DELEGATED APPLICATION REPORT

SITE ADDRESS: Abbey Gardens, 4-6 Abbey Street, Reading, RG1 3BA

APPLICATION NUMBER: PL/26/0091

PROPOSAL: External works to partial areas of all elevations at ground floor level and all areas of each elevation from 1st to 7th floor level, including replacement windows and doors, installation of brickwork following removal of existing glazing, the provision of Juliet balconies on all elevations and protruding balconies on the east and south elevations at 2nd floor level and above, and other associated works.

Below: Existing (left) and proposed views from Chestnut Walk

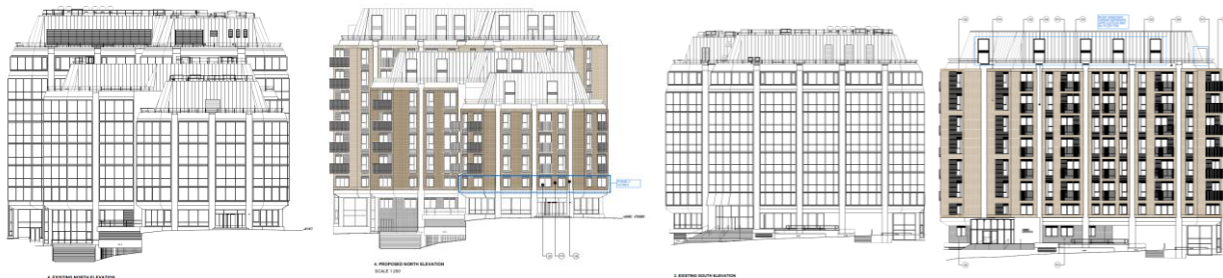
7.4.2 The use of brickwork is supported by officers, as it was by Reading DRP at pre-application stage. The applicant has chosen to bring the proposals forward with three main brick types, with a grey brick largely serving the southern block, a brown brick largely serving the central and northern blocks, charcoal/slate-blue brick to link and provide detail. The combination and location of the chosen brick types work successfully in the context of the nearby heritage assets, in particular the lighter brick being further away from the Abbey Ruins to avoid seeking to compete with its primacy. The changes in brick types across the building also help break up its overall massing into appearing as a series of structures, rather than a single block.

Above left: existing & proposed north elevation. Above right: existing & proposed south elevation. Below: Existing and proposed views looking north towards the Abbey Ruins.

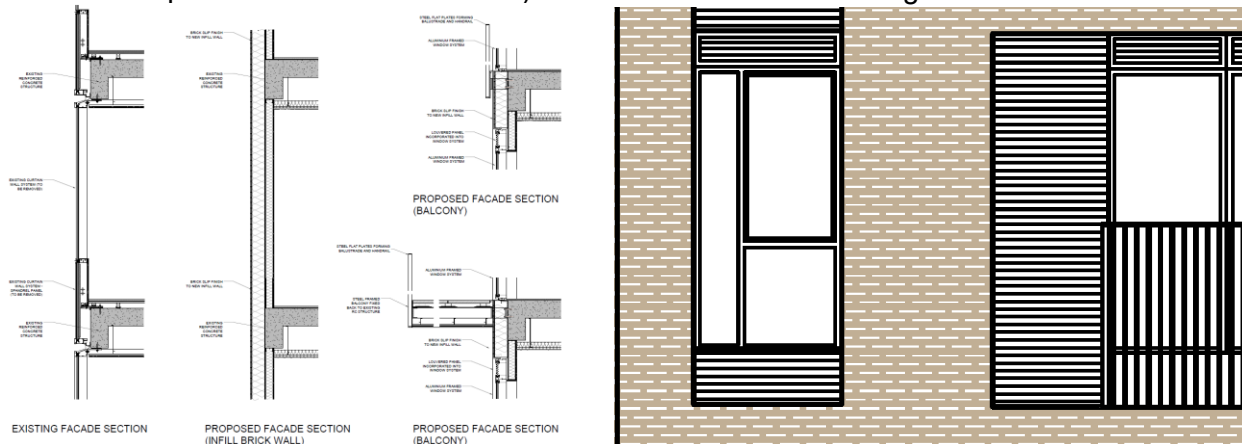
- 7.4.4 It is also welcomed that the applicant has indicated a suitable attention to detail in provided sectional plans to help understand the nature and extent of the brick slip system proposed for the buildings. This has provided reassurance to officers that the proposed system has been carefully advanced and has the potential to be implemented successfully. It is also welcomed that the applicant has complimented the proposed brickwork choices with high quality aluminium framed windows, galvanised steel protruding balconies (including complimentary painted soffits so as to maintain the appearance of the balconies from street level) and suitable juliet balconies too. The combined result is a coherent design response, which sits comfortably as a building in its own right (in the context of the anticipated future residential use) and within its sensitive setting.

Existing and proposed views from Kings Road, looking west.

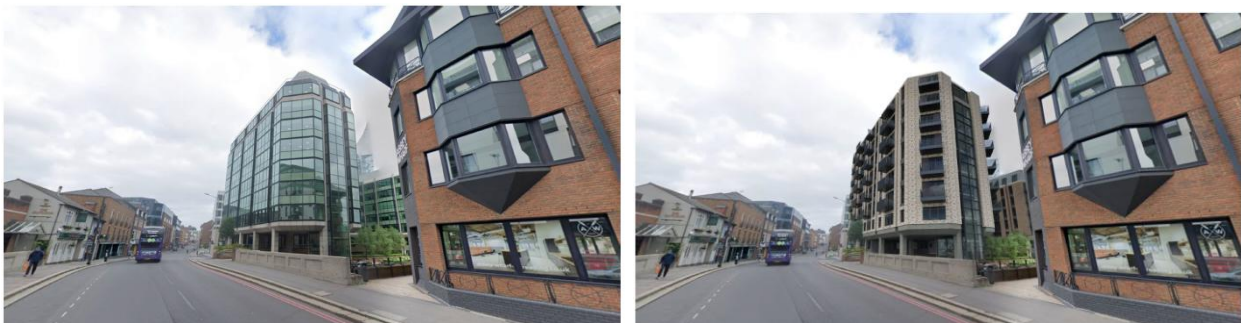
7.4.7 It is also confirmed that the proposals would satisfactorily align with the roof level works already approved at the site (see relevant history section above), bearing in mind that these proposals involve no roof level works.
